SERVICE BULLETIN No.1179

COACH MODEL	: C2045
BULLETIN TYPE	: Product Improvement
SECTION	: Section 11 – Body and accessories
DATE	: March 08, 2006
SUBJECT	: Engine compartment door insulation
TERMS & CONDITIONS	: No claims will be accepted with reference to this Bulletin.

Figure 1: Snap buttons retaining the insulation (lower buttons shown only)

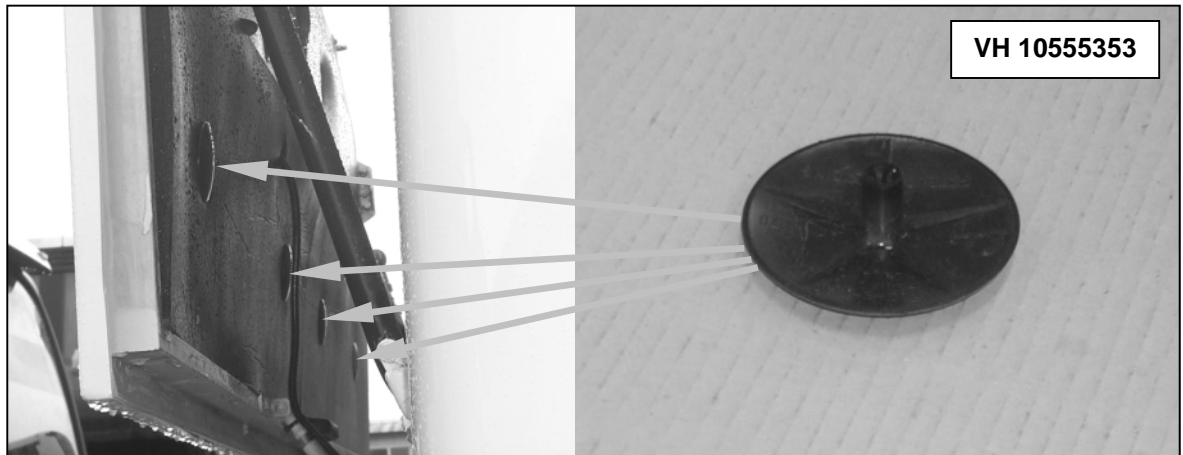
1. The installation hardware for the insulation of the engine compartment door has been revised.
2. The plastic snap buttons securing the insulation inside the door have been replaced by four mounting strips, which are riveted to the doorframe.
This ensures lasting retention.
3. The procedure in this Bulletin shows how field coaches can be converted to the new spec.
Instructions on how to do small repairs have also been included.

- 4) Working in between the door and the coach, lever off all fourteen snap buttons securing the insulation with a large flat tip screwdriver (see Figure 1). During removal, place a piece of plywood between the tip of the screwdriver and the insulation to prevent damage. Discard the buttons.

Figure 2: Location and installation dimensions of insulation mounting strips.

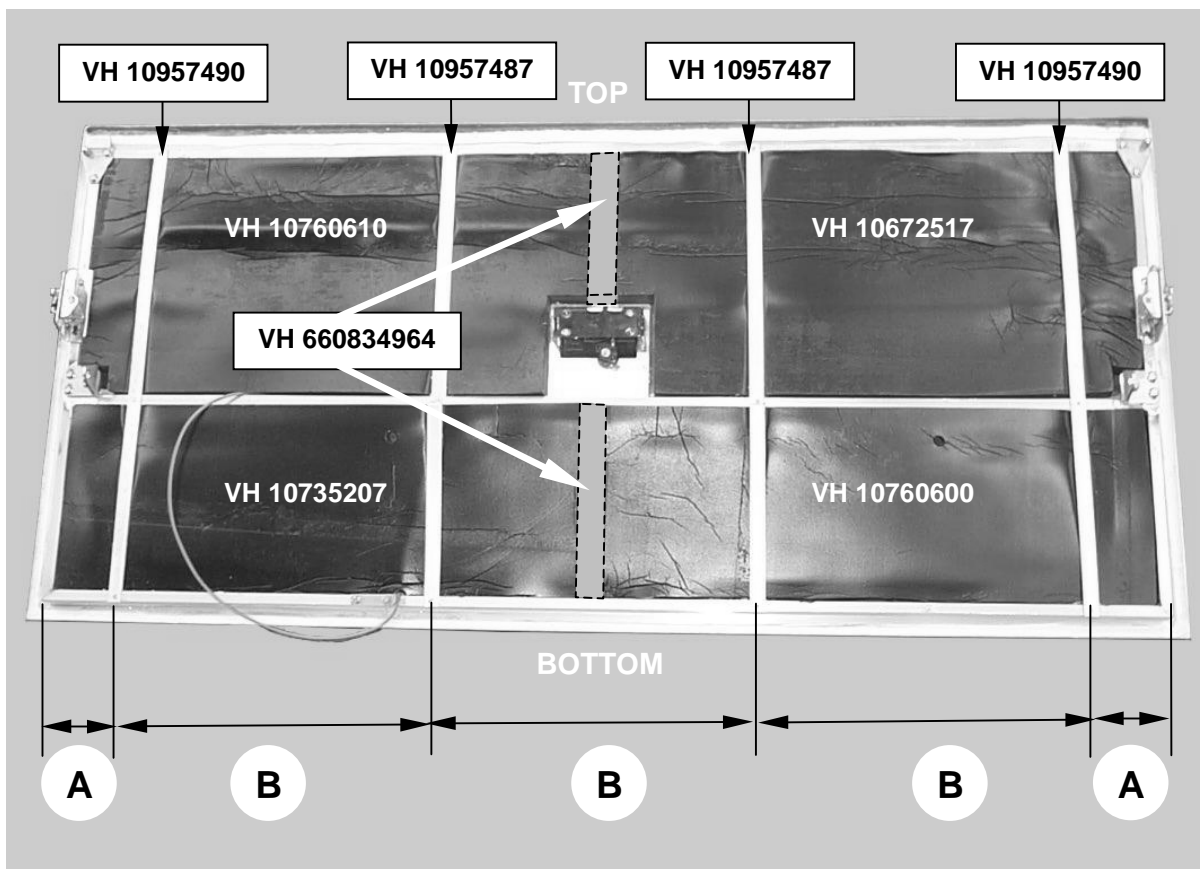
- 5) Refer to Figures 2 and 3 to install the mounting strips vertically one by one - the flat strips close to the door edges, the stepped strips close to the center part of the door.

A = approximately 5.5 inch; B = approximately 23 inch between mounting strip centerline

Figure 3: Installation of the stepped strips in the center part of the door. Note tank tape VH 660834964 joining the insulation panels

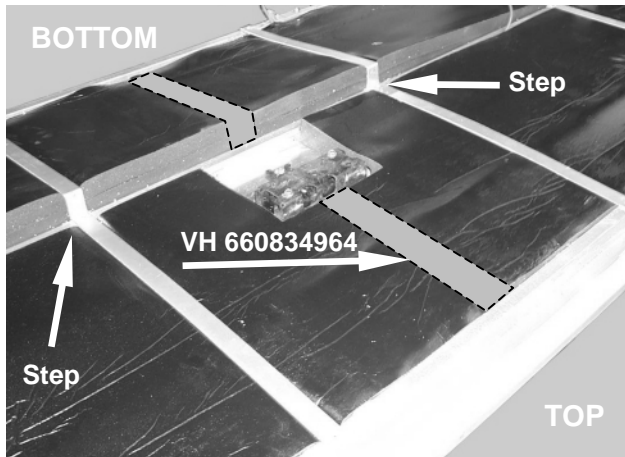
- 6) Referring to Figures 2 and 3, join the mating edges of the insulation panels in the center with tank tape VH 660834964.
- 7) Switch the starter motor inhibitor switch on. Remove the strap holding the door steady and close it.

Figure 4: Strips are riveted to the door frame rails

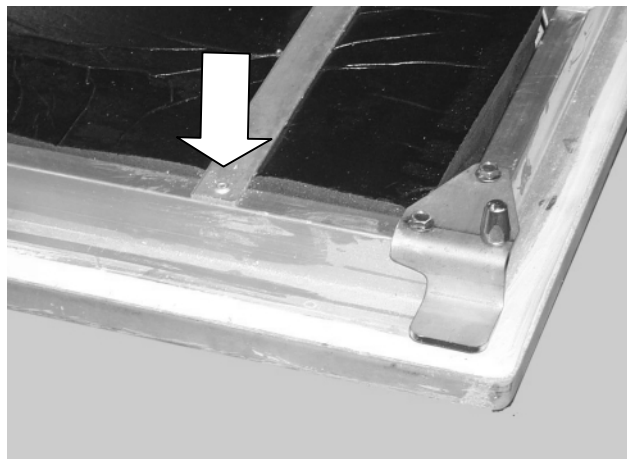
- Carefully slip the strip between the door lock pull rod and the insulation.
- Place the strip in its appropriate location shown in Figure 2. Make sure the strip edges run parallel the doorframe. Secure temporarily with clamps.
- Using the holes in the strip as a template, drill two 13/16-inch (5.1 mm) Ø holes in the frame rails, one at the top, one at the bottom.
- Secure the strip with two water tight rivets VH 660611691 (see Figure 4).
